Coaxlink

Flash EEPROM Change Note

1633 Coaxlink Quad G3, 1633-LH Coaxlink Quad G3 LH, 1637 Coaxlink Quad 3D-LLE

Visual Identification

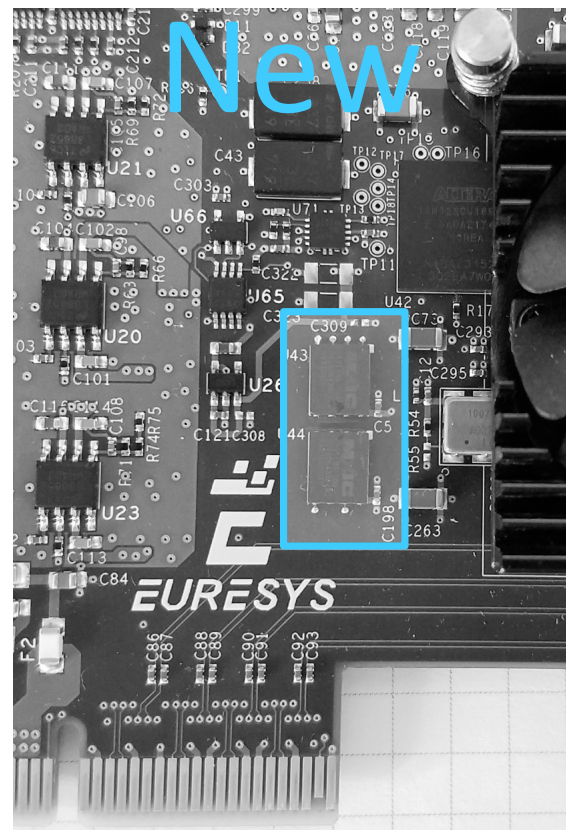
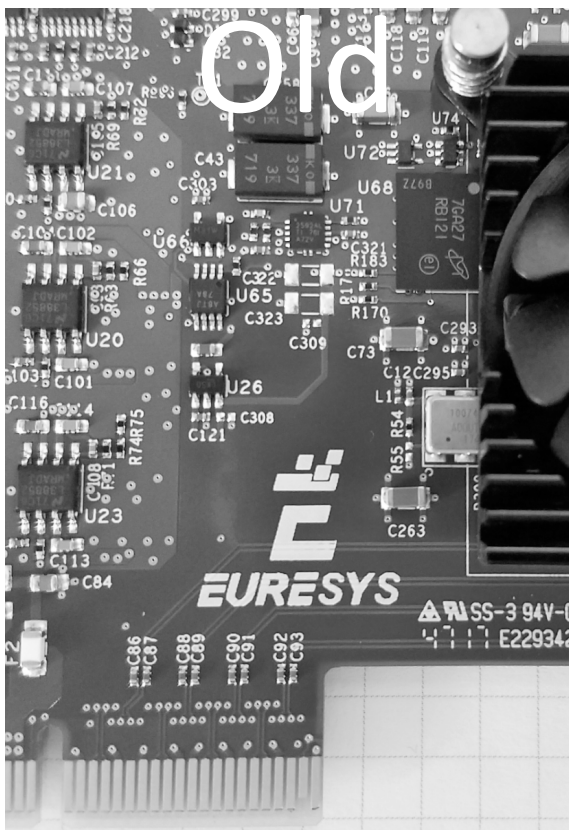
New 1633 Coaxlink Quad G3, 1633-LH Coaxlink Quad G3 LH and 1637 Coaxlink Quad 3D-LLE can be visually identified by the two SPI Flash Memory IC's located between the fan and the PCI Express connector.

See the blue rectangle in the following drawing:
